DECISION № RRJ0000-OR-470-8879

on one-time hinge fitting elevator inspection with respect to the lack of hub (bush) p/n T7.92.5101.107.000.73/A.

Figure 1

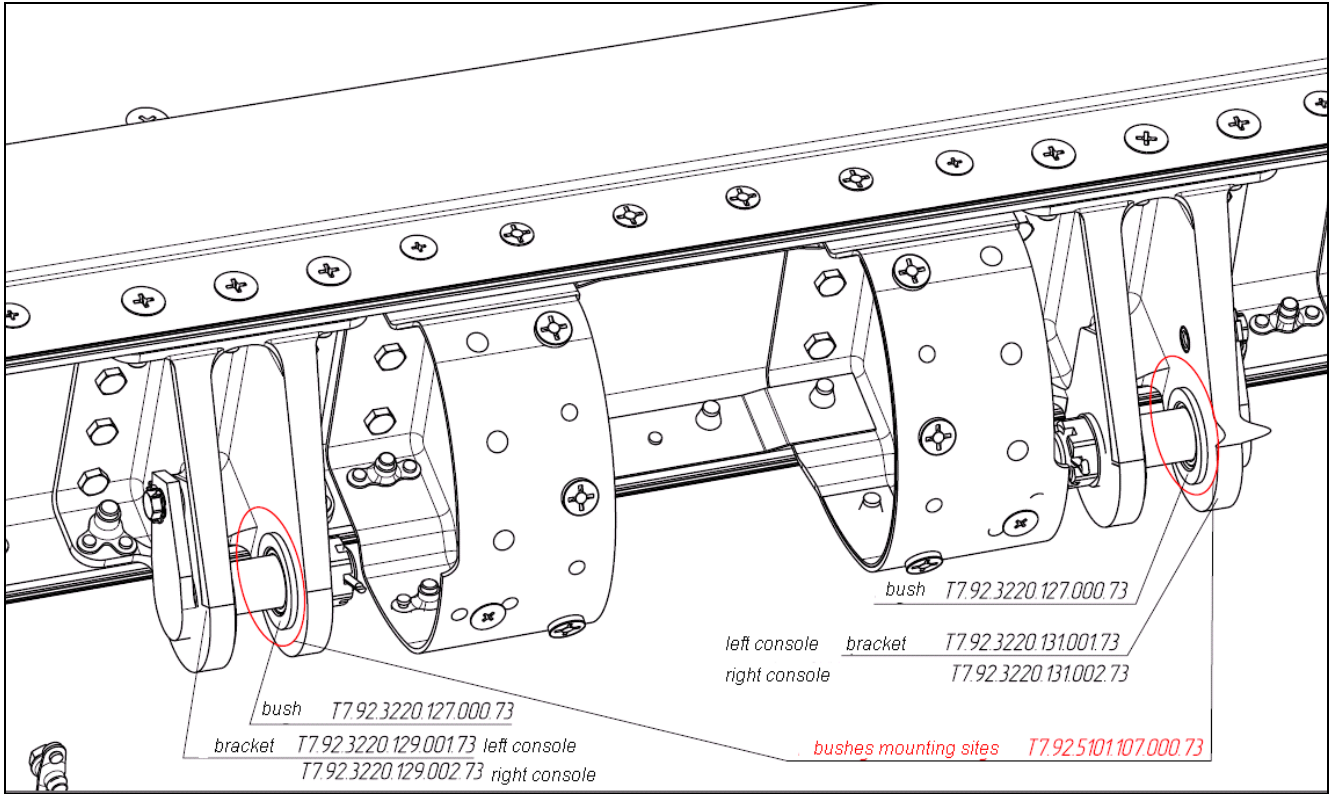
During the aircraft RRJ-95 operation the elevator play (backlash) nonconformity events due to floating bush p/n T7.92.5101.107.000.73/A missing at the mounting bracket were revealed and as a consequence the bolt T7.92.5101.101.000.73/B galling (please, refer to fig. 1).

The elevator backlash symptom effect was inability for the autopilot to maintain the prescribed altitude (within 30-50 ft range altitude).

The lack of the bush T7.92.5101.107.000.73/A the elevator actuator mounting bracket (1-C273, 2-C273, 3-C273, 4-C273) is caused by non-compliance with Design Documentation performed during the manufacturing process. To reveal if the floating bush T7.92.5101.107.000.73/A is not installed at the elevator actuator mounting bracket it is decided to take the following actions

1. At their base airports all Operators' RRJ-95 fleet must be subjected to a one-time inspection of the elevator backlash in accordance with AMM 55-20-00-200-801 during the next maintenance check (WY-check) but no later than 03.08.2016.

2. If no out-of-design backlash result is found during the inspection in accordance with AMM 55-20-00-200-801, aircraft operation is allowed to be with no restrictions applied, provided that subsequently the elevator inspection is held in accordance with MPD and AMM.

3. If the elevator backlash is proved to be out-of-design limits as stated in the AMM 55-20-00-200-801, then the elevator actuator should be detached from the related brackets p/n T7.92.3220.131.001.73/D, T7.92.3220.131.002.73/D, T7.92.3220.129.001.73/C.T7.92.3220.129.002.73/C as required by the AMM 55-26-00-220-801 “ Detailed hinge inspection of fittings and elevator actuator bracket”. Close attention should be paid to detect if the bush p/n T7.92.5101.107.000.73/A is installed at the actuator bracket on the elevator.

3.1. If the lack of bush p/n T7.92.5101.107.000.73/A at the actuator mounting bracket is found, then the mount attachments inspections of, brackets should be held in order to reveal any damages, galling and make a NDT report containing the description (sizes, damages' nature, etc.) by performing the subsequent actions:
